**ADDENDUM NO. 1
NEW ELEVATOR
AT MURPHY ELEMENTARY SCHOOL
ROUND LAKE SCHOOL DISTRICT NO. 116
PROJECT NO. 23170**

Board of Education
Round Lake School District 116
884 West Nippersink Road
Round Lake, Illinois 60073

A1.1

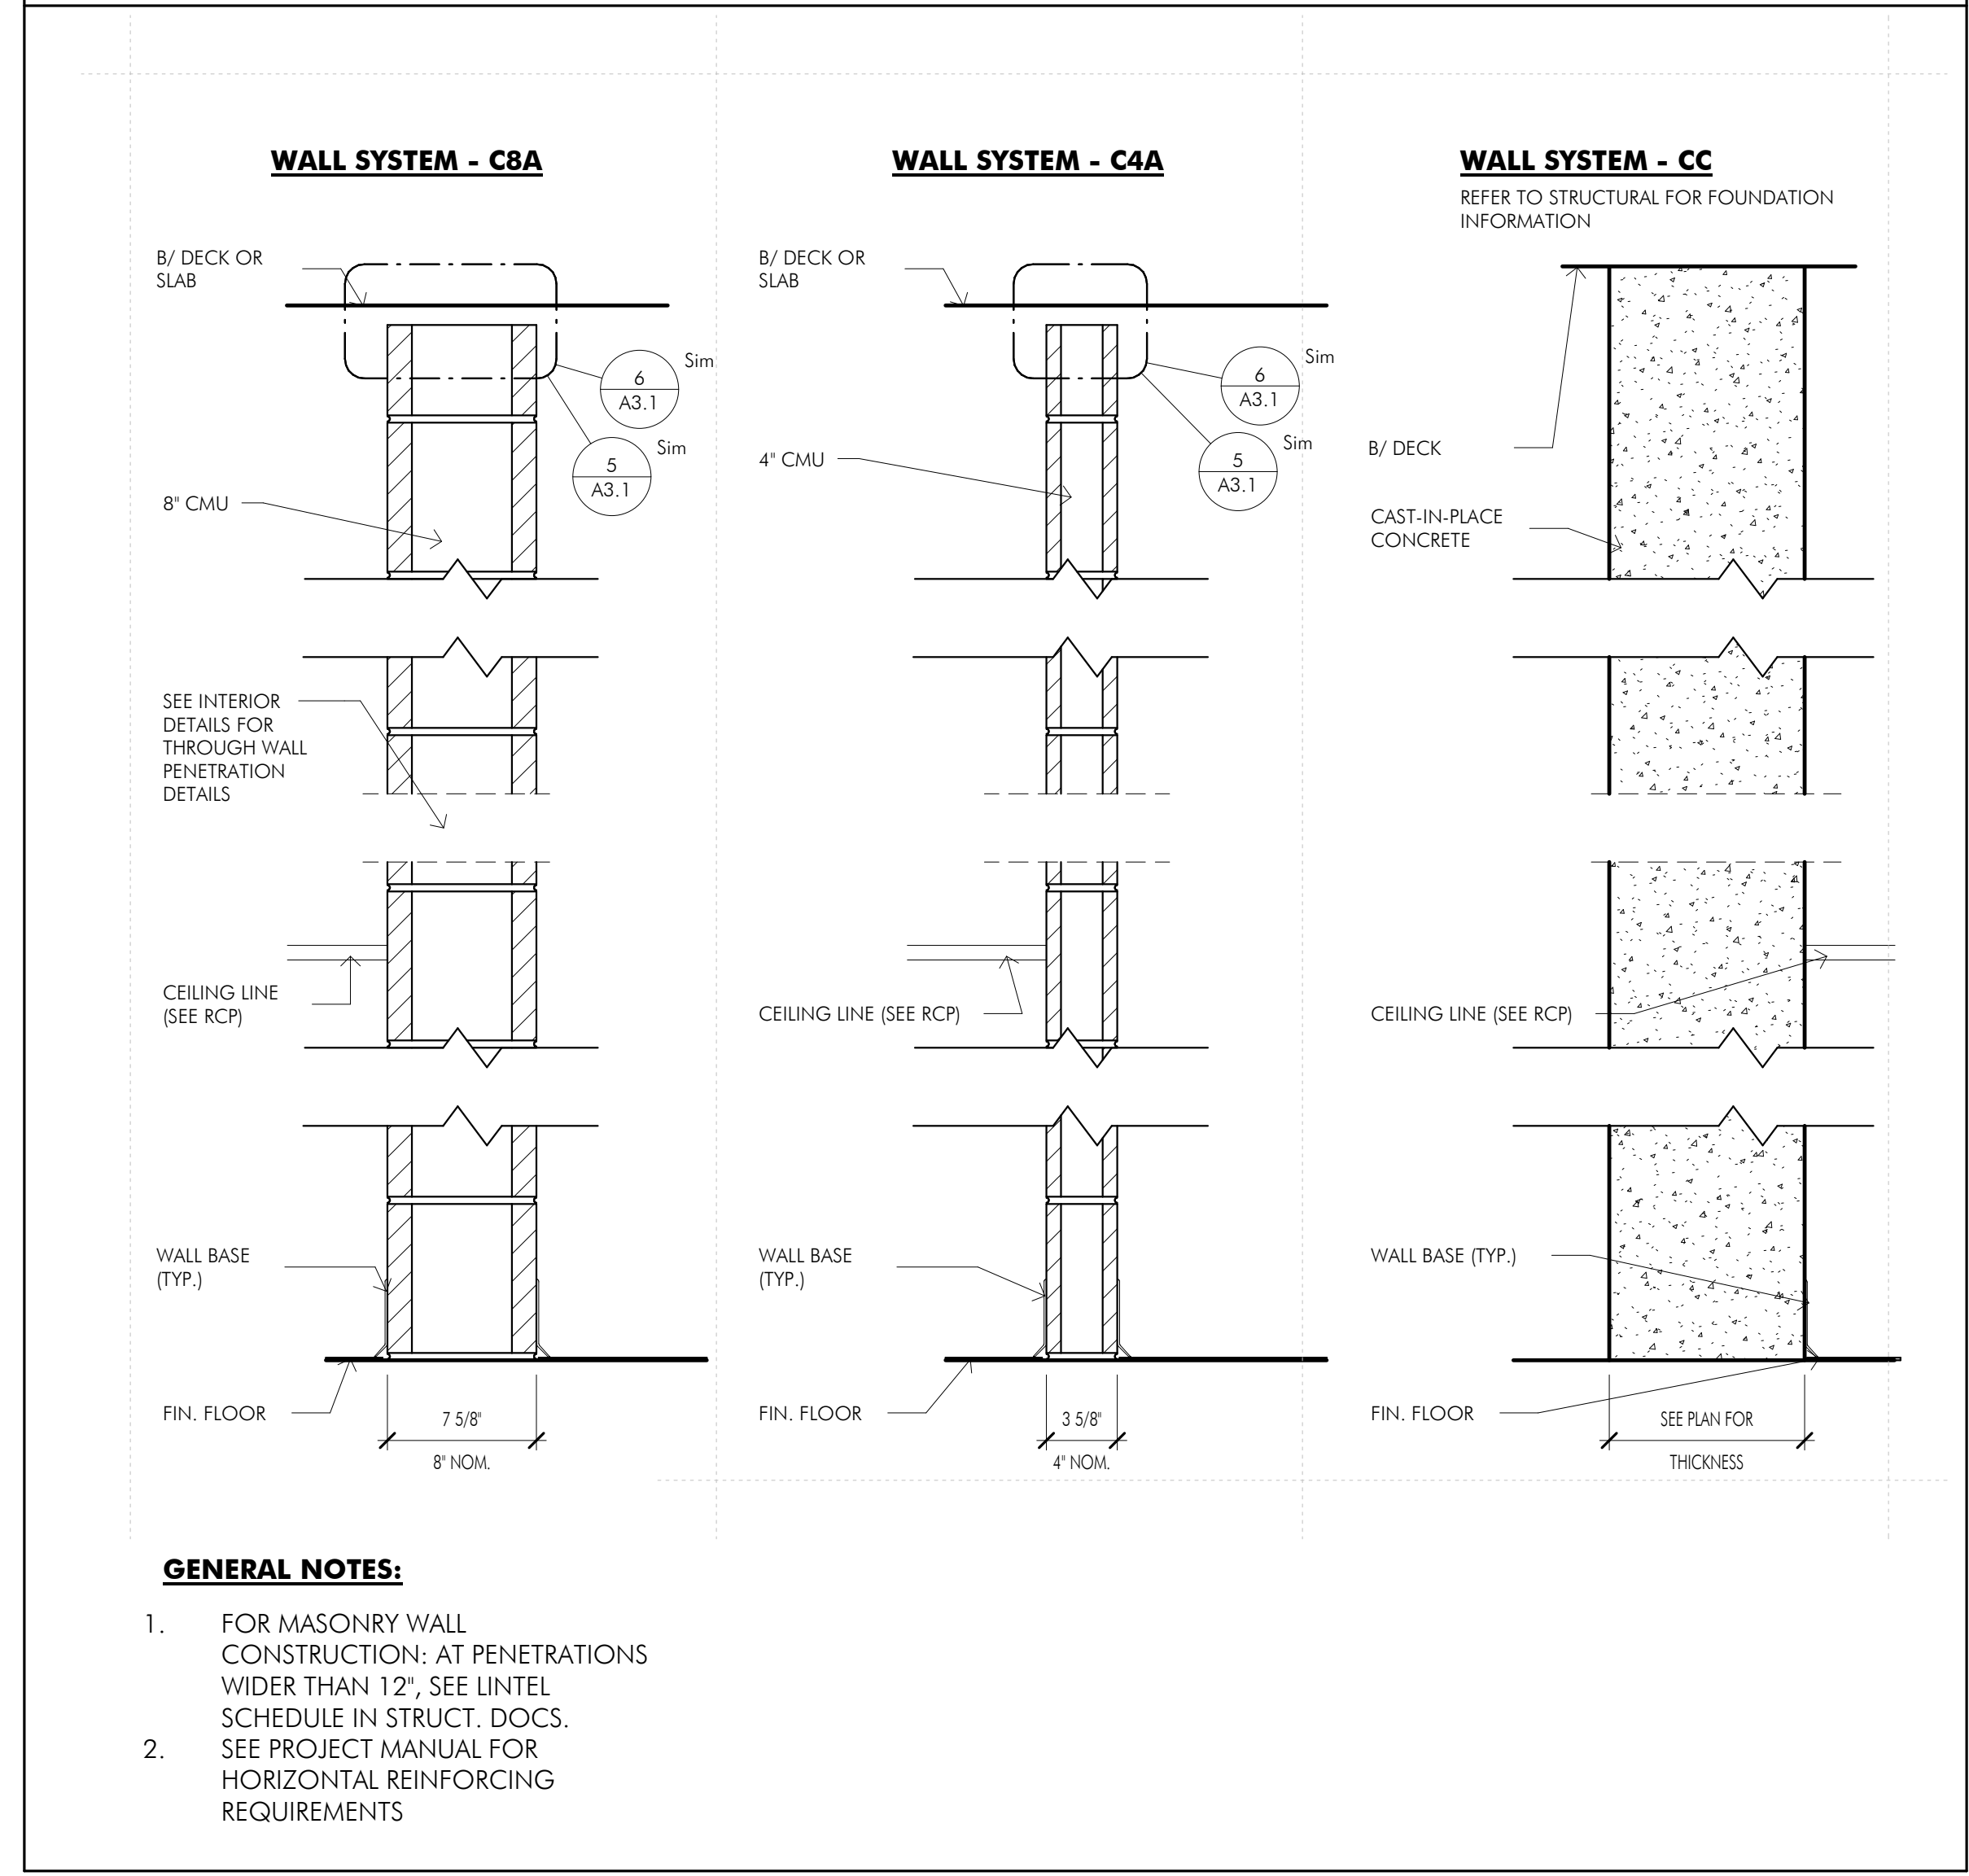
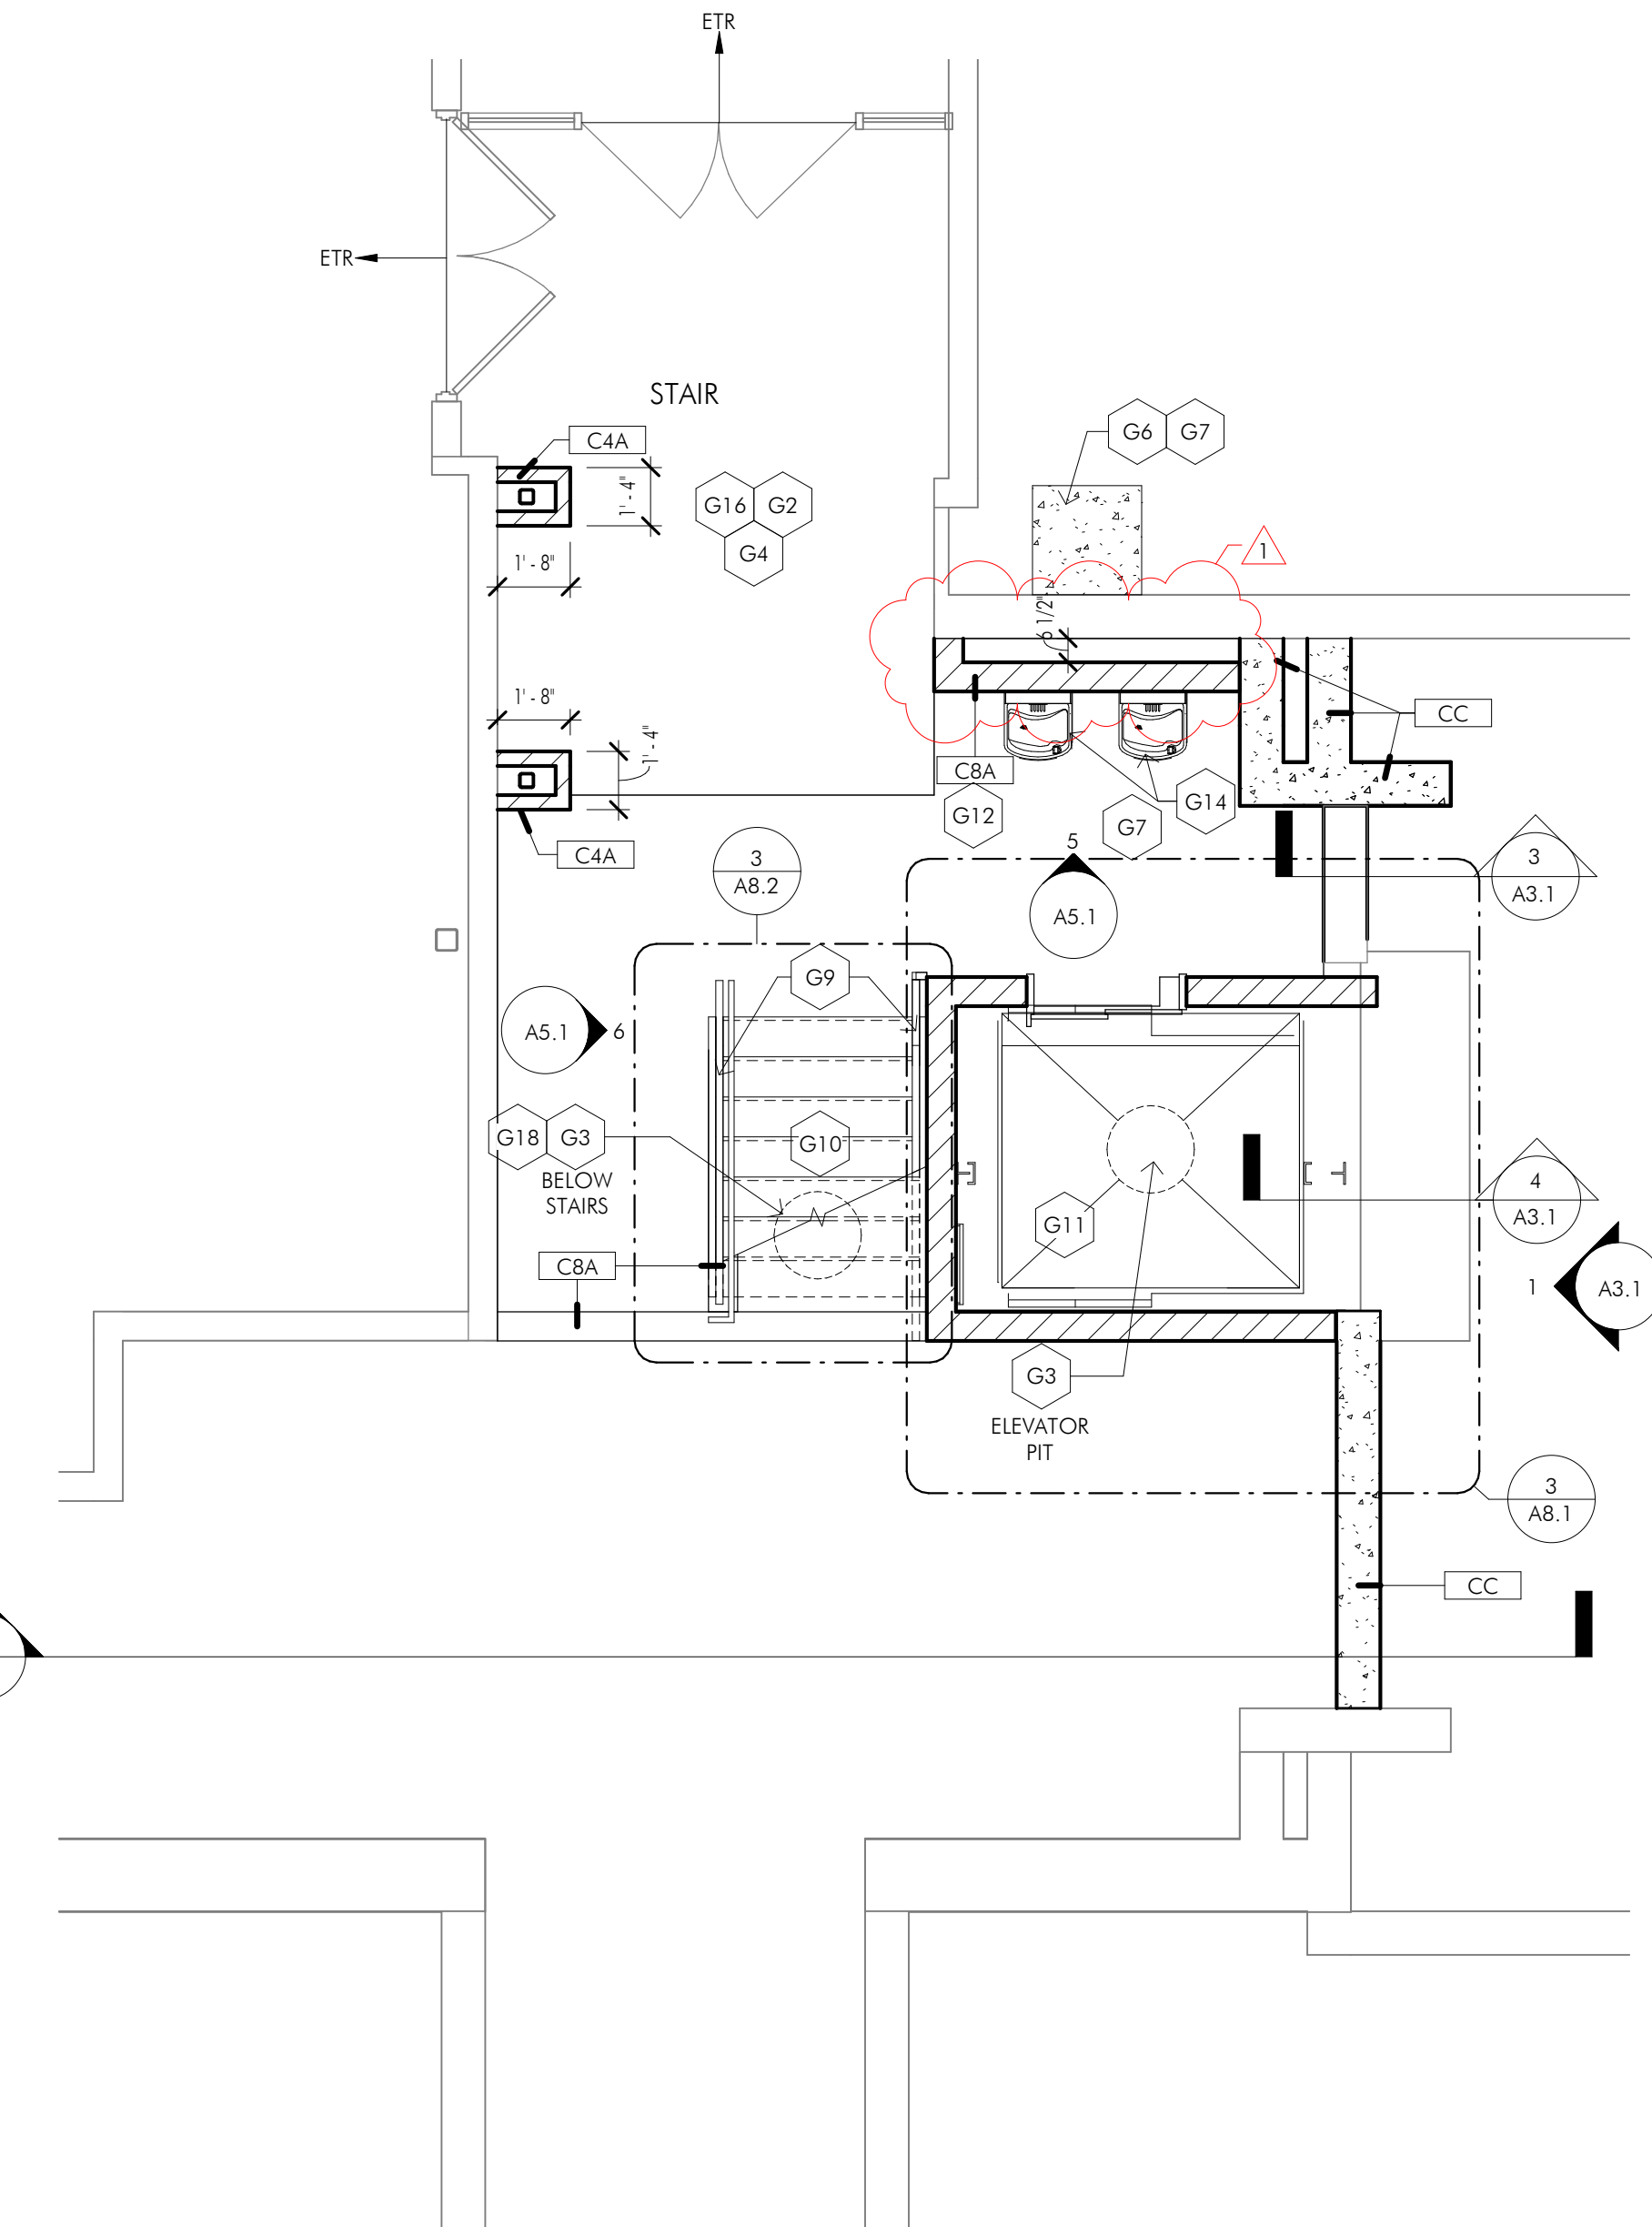
ITEM NO. 3: DRAWINGS, SHEET A1.1

1. Revised plumbing wall location.
